EMERGENCY DEPARTMENT & CANCER CENTER EXPANSION

CCD 04

2ND FLOOR
PLAN - NORTH -
HVAC

M4
12

2ND FLOOR PLAN - NORTH - HVAC

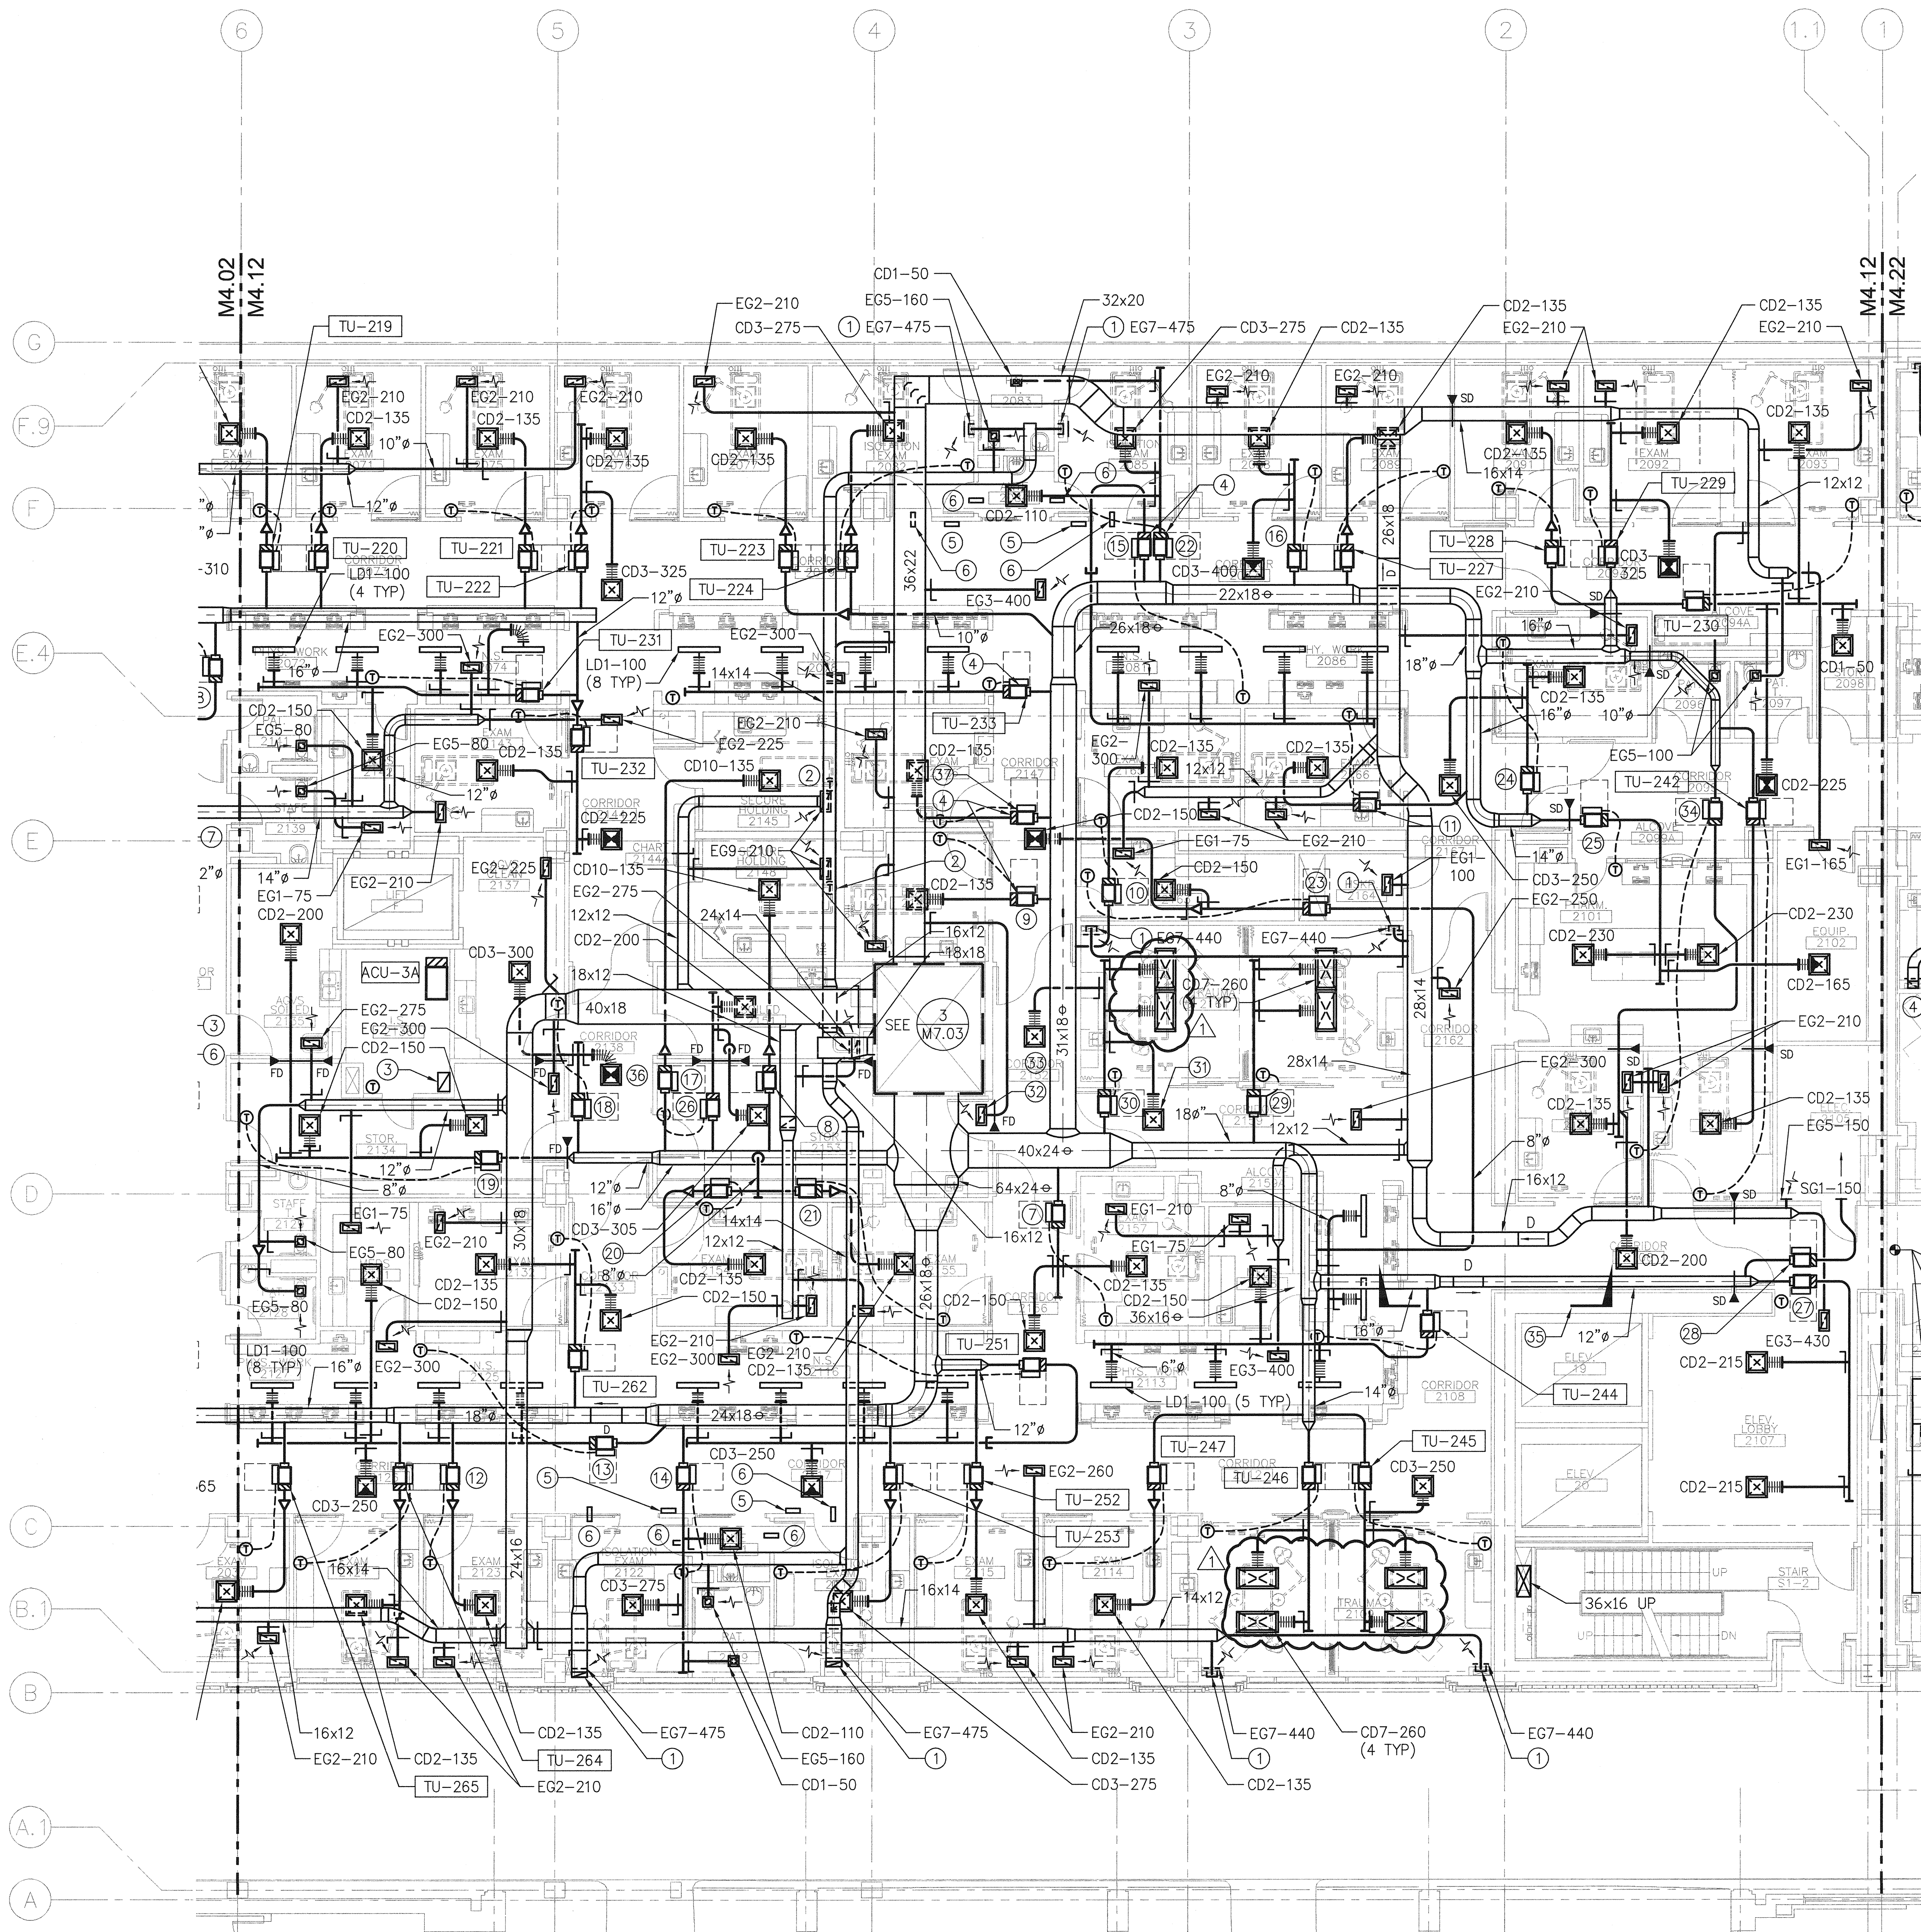
- 1 18x6 EXHAUST DUCT DOWN IN CHASE. LOCATE GRILLE AT 6" ABOVE FINISHED FLOOR AND PROVIDE VOLUME DAMPER AT GRILLE.
- 2 MOUNT TEMPERATURE SENSOR IN EXHAUST DUCT BEHIND SECURITY GRILLE.
- 3 24x14 EXHAUST DUCT UP AND DOWN.
- 4 10" CONNECTION TO BIOSAFETY CABINET. DIRECT CONNECT DUCT TO THE CABINET. BALANCE TO 360 CFM EXHAUST.
- 5 ISOLATION ROOM PRESSURE MONITOR. SEE CONTROL DIAGRAMS.
- 6 ISOLATION ROOM PRESSURE SENSOR.
- 7 TU-250.
- 8 TU-257.
- 9 TU-238.
- 10 TU-235.
- 11 TU-236.
- 12 TU-263.
- 13 TU-290.
- 14 TU-254.
- 15 TU-289.
- 16 TU-226.
- 17 TU-259.
- 18 TU-260.
- 19 TU-261.
- 20 TU-256.
- 21 TU-255.
- 22 TU-225.
- 23 TU-237.
- 24 TU-239.
- 25 TU-240.
- 26 TU-258.
- 27 TU-291.
- 28 TU-243.
- 29 TU-248.
- 30 TU-249.
- 31 CD2-150.
- 32 EG2-305.
- 33 CD2-175.
- 34 TU-241.
- 35 SEE SECTION F ON M8.02.
- 36 CD2-170.
- 37 TU-234.
